AGENDA PLANNING COMMISSION

July 27, 2026

5. PUBLIC HEARING - LAND USE FILE #08-05/26 – Application for Site Plan Review to construct a new gymnasium on the Regis High School campus located at 550 W Regis Street in the Public/Semi-Public (P).

TO: Chairperson Larry McKinley and Planning Commission Members
FROM: Jennifer Siciliano, Director of Community and Economic Development
DATE: July 27, 2026
SUBJECT: Phillips Estates III Detailed Master Planned Development Approval for a 22-lot Master Planned Development subdivision
120 DAYS ENDS: August 15, 2026 (has been extended)

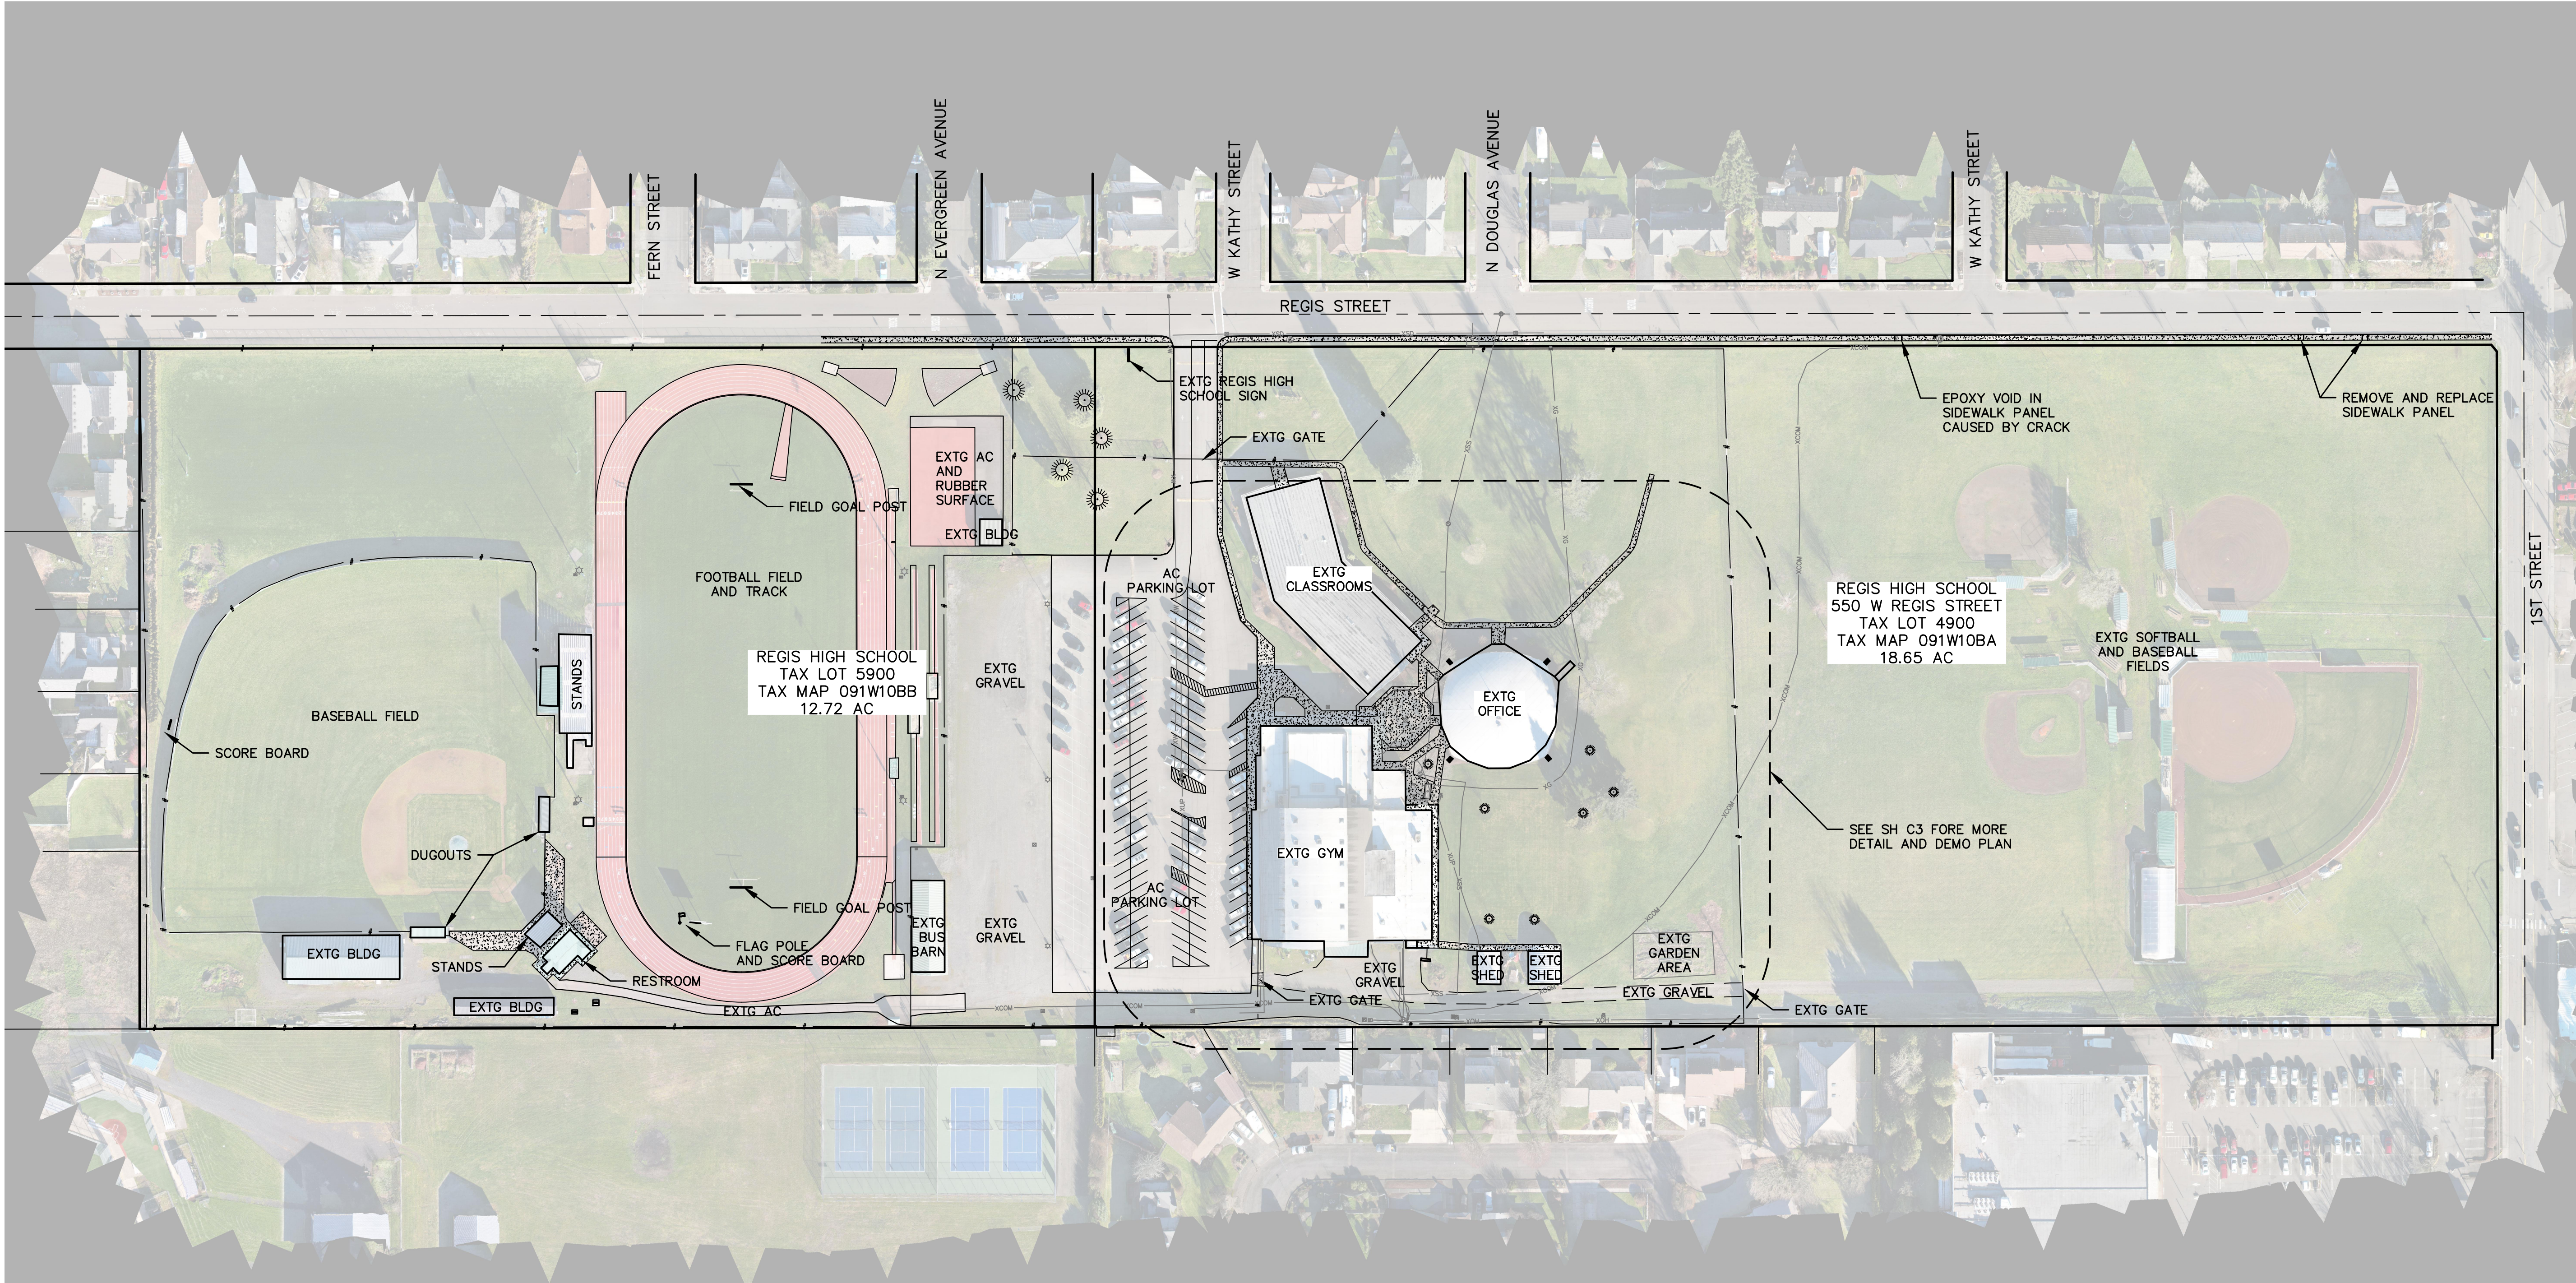
Finding: Sheet C3 of the site plan submitted does not show any designated handicapped spaces. The aerial image on sheet C2, shows 4 parking spaces with surface markings indicating they are handicapped parking spaces.

- b. Repair or replace the W. Regis Street sidewalk panels identified on Sheet C2 of the Existing Conditions survey map.

- REGIS STREET SIDEWALK:
- CITY OF STAYTON PUBLIC WORKS IS REQUIRING CONFIRMATION THAT THE EXISTING SIDEWALK ALONG REGIS STREET HAS NO SAFETY OR TRIPPING HAZARDS.
 - A WALK WAS DONE WITH MICHAEL SCHMIDT OF STAYTON PUBLIC WORKS ON 4/3/2026. TWO SIDEWALK PANELS WERE IDENTIFIED THAT NEED TO BE REMOVED AND REPLACED. ONE SIDEWALK PANEL NEEDS EPOXY TO FILL IN A VOID CAUSED BY A CRACK.
 - AREAS SHOWN BELOW ARE APPROXIMATE. COORDINATE WITH ENGINEER TO IDENTIFY EXACT PANELS THAT NEED TO BE REPAIRED.
